# Access Compliance Report

## Public Rights-of-Way

Intersection ID: 13098	Main Street: S_CHURCH_ST	Cross Street: LINCOLN_ST	Location: SE
ADA ID: 18B00135EB83	Ramp Type: PerpDiag	Initial Pass/Fail: Fail	Overall Compliance: No
Severity Score: 13.75			
Codes/Mitigation Info/Possible Solution		Field Measurements/Component Compliance

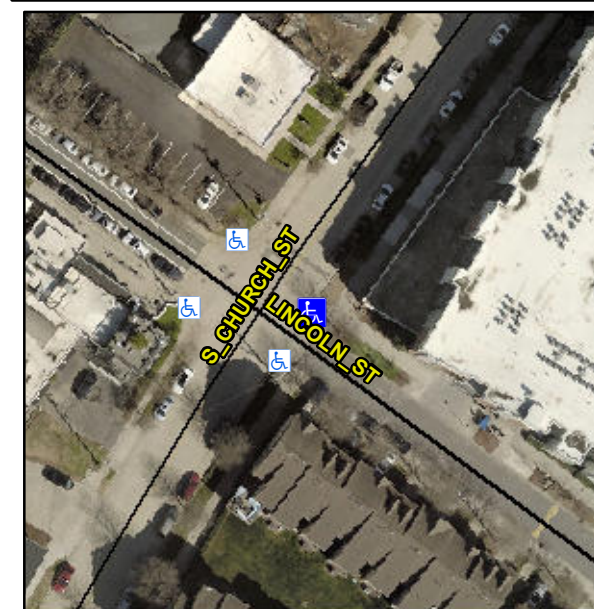
**Remove & Replace Curb Ramp With Two New Directional Ramps or Equivalent.**

**Not Found, R304.2.2, R304.5.3**

Compliance	Description	Data	Compliance	Description	Data
N/A	Ramp Length (in)	64.0	No	Ramp Slope (%)	9.4
Yes	Ramp Width (in)	48.0	No	Ramp XSlope (%)	4.9
N/A	Flare Type LT	N/A	N/A	Flare Type RT	N/A
N/A	Flare Slope LT (%)	N/A	N/A	Flare Slope RT (%)	N/A
N/A	Flare Traversable LT?	N/A	N/A	Flare Traversable RT?	N/A
N/A	Landing Length (in)	N/A	N/A	DWS Provided?	N/A
N/A	Landing Width (in)	N/A	N/A	DWS Contrast?	N/A
N/A	Landing Slope (%)	N/A	N/A	DWS Length (in)	N/A
N/A	Landing X Slope (%)	N/A	N/A	DWS Full Width?	N/A
N/A	Landing Curb? (Y/N)	N/A	N/A	DWS Offset (in)	N/A
N/A	Shared Landing?	N/A			
N/A	Gutter Ponding?	N/A	N/A	Gutter Slope (%)	N/A
N/A	Gutter Lip Ht (in)	N/A	N/A	Gutter X Slope (%)	N/A
N/A	Painted X Walk1?	No	N/A	Painted X Walk2?	No
	X Walk 1 Direction	To NW		X Walk 2 Direction	To SW
N/A	X Walk 1 Width (in)	N/A	N/A	X Walk 2 Width (in)	N/A
	X Walk 1 Slope (%)	2.9		X Walk 2 Slope (%)	0.7
	X Walk 1 X Slope (%)	0.7		X Walk 2 X Slope (%)	0.9
